Engineering Design Analysis of Recreational Opportunities in the Good Harbor Region

Mansfield Land Use Consultants
830 Cottage View Drive, Suite 201
Traverse City, MI 49685

April 26, 2024

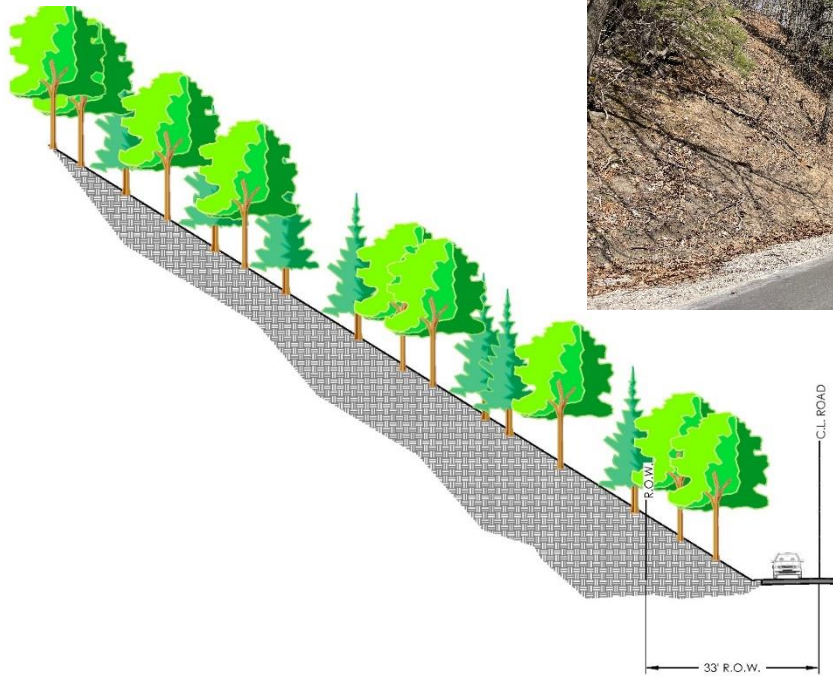
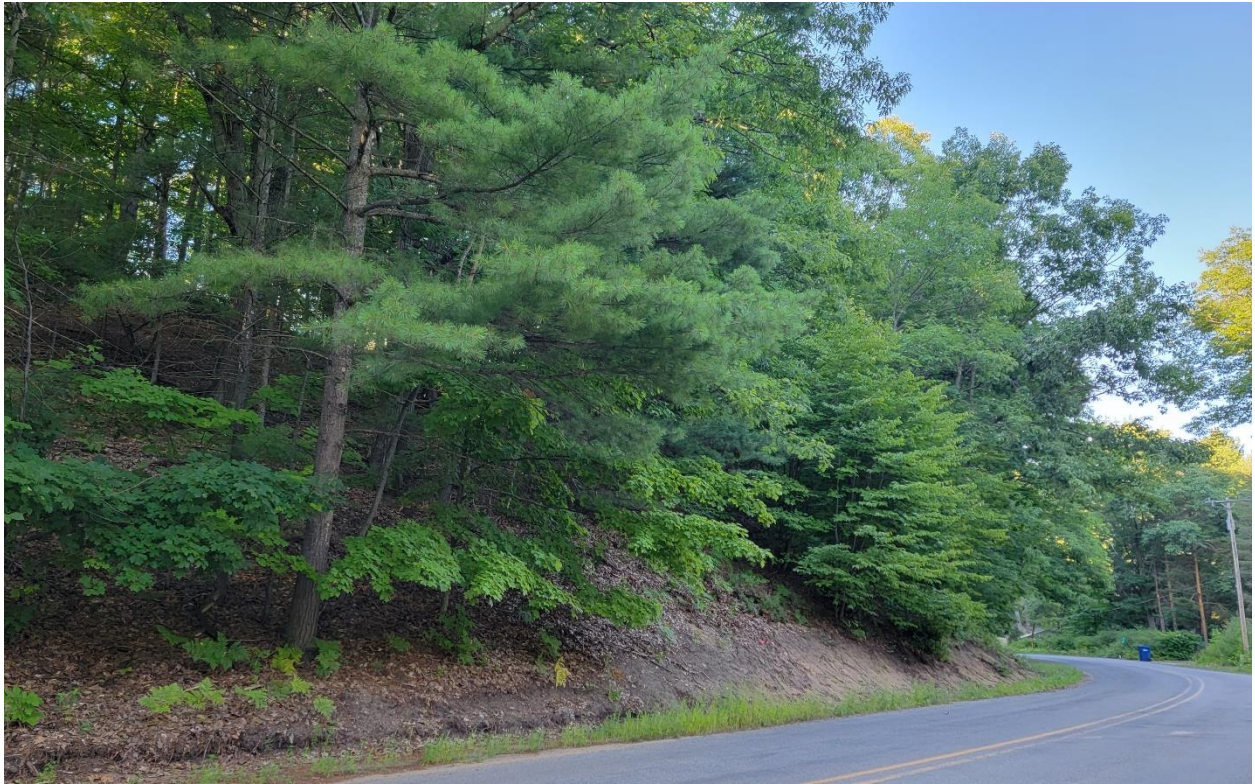
In an attempt to illustrate the existing situation, the standard of care required to meet design standards, and the incorporation of general practices of dealing with this type of encroachment and restoration, we have provided five independent cross sections as they would meet the standard of care and the scale of invasion into the dunes (See Appendix for full sized cross sections):

- Cross section of existing dunes,
- Cross section meeting LCRC drainage requirements with existing road width (11' lane width),
- Cross section meeting LCRC drainage requirements with LCRC requirements for new road construction (15' lane width),
- Cross section for proposed Trail construction using a multi-tiered retaining wall design,
- Cross section for proposed Trail construction using a single-tiered retaining wall design.

Final engineering designs may discover ways to lessen impact or find ways to reduce the design requirements, but these facts will remain: a significant portion of the tree canopy in this section along TLR will be cleared, a significant portion of the State regulated Critical Dune Area will need to be removed and hauled away to a land fill area, extensive retaining walls will need to be built for 950' along TLR, costs will be significant, and the result will be a significant character change in this scenic wilderness road. These aspects cannot be overlooked despite discussions about the type of retaining wall material or how the retaining wall can be designed more aesthetically. The bigger question is why this significant alteration is even necessary or deemed acceptable in Trail planning, especially when alternatives for creating recreational opportunities exist.

LCRC DRAINAGE REQUIREMENTS

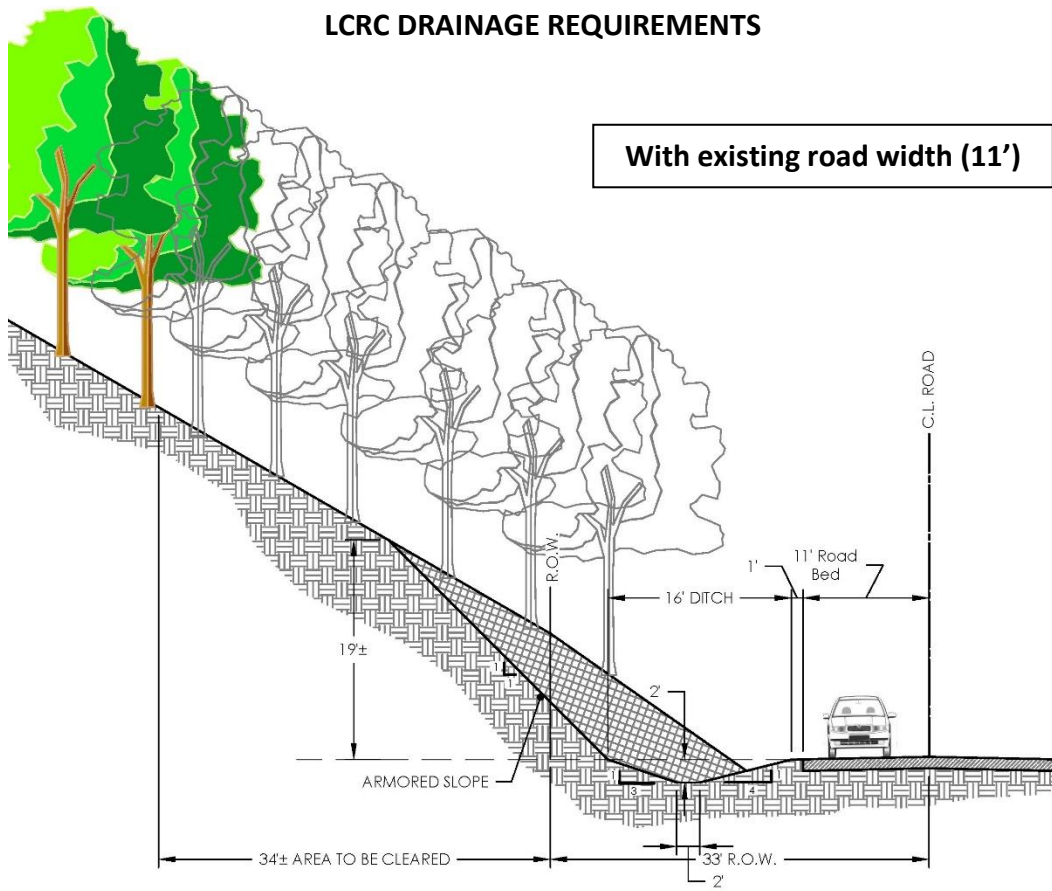
With existing road width (11')

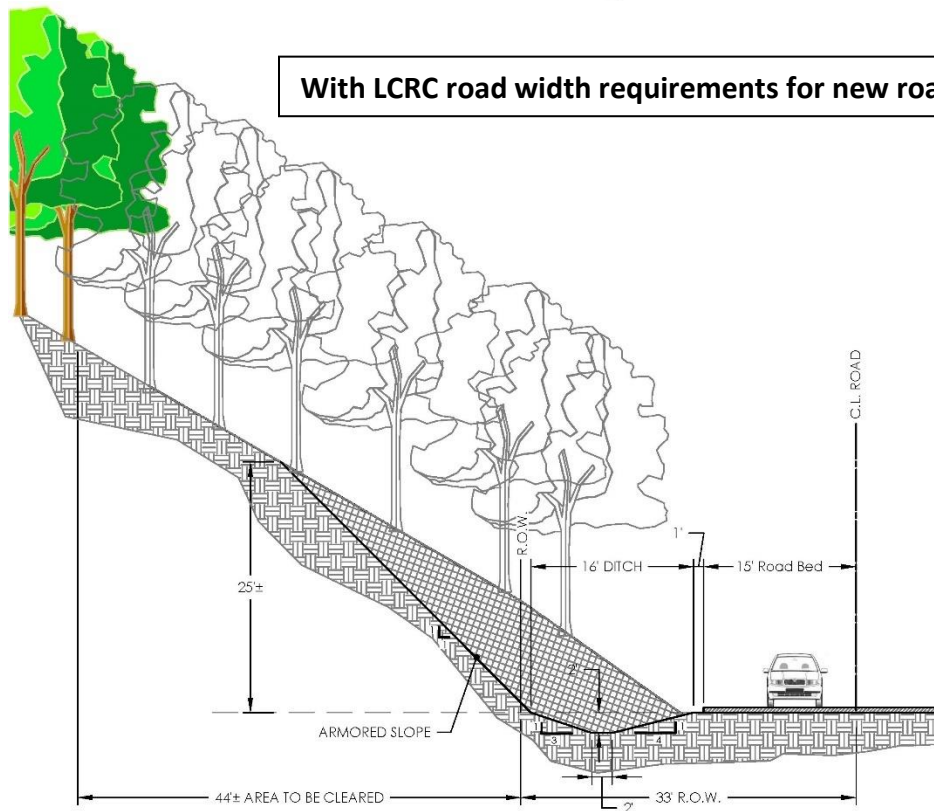
With LCRC road width requirements for new roads (15')

SINGLE-TIER DESIGN

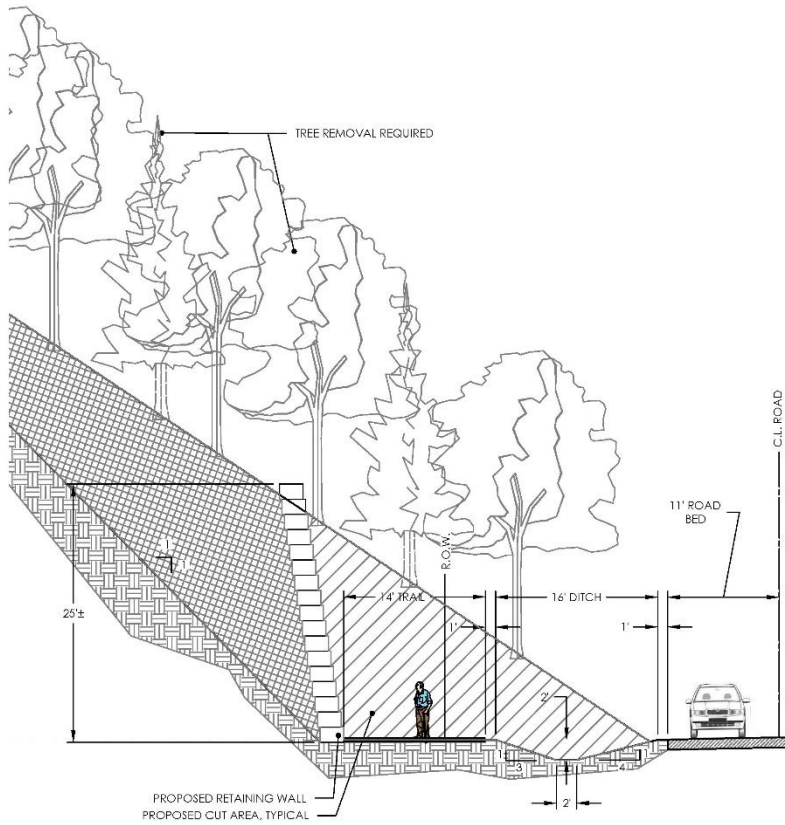
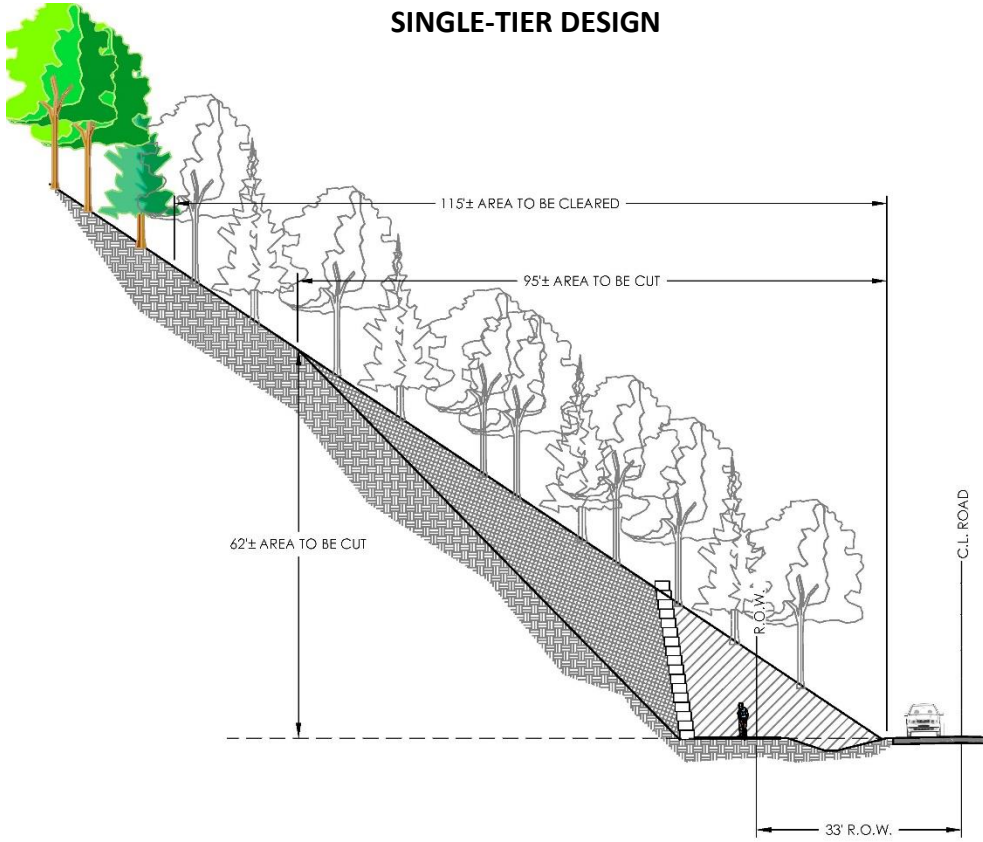
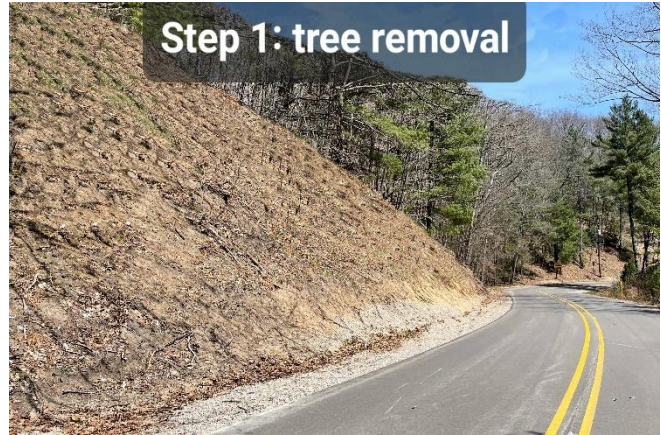
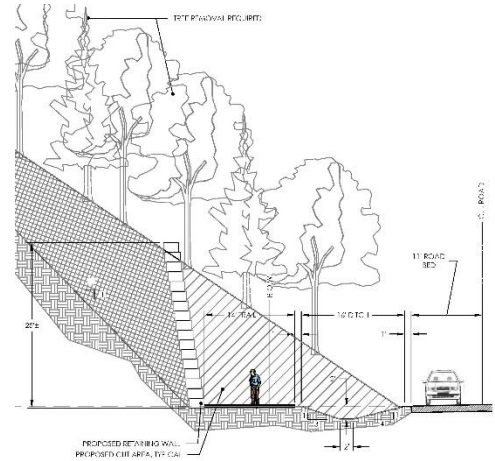
THIS EXHIBIT ILLUSTRATES MAINTAINING THE EXISTING PAVED ROAD BED WITH DEVELOPING THE STANDARD DRAINAGE DITCH, INCORPORATING THE TRAIL SECTION AND A SINGLE 25 FOOT HIGH RETAINING WALL.
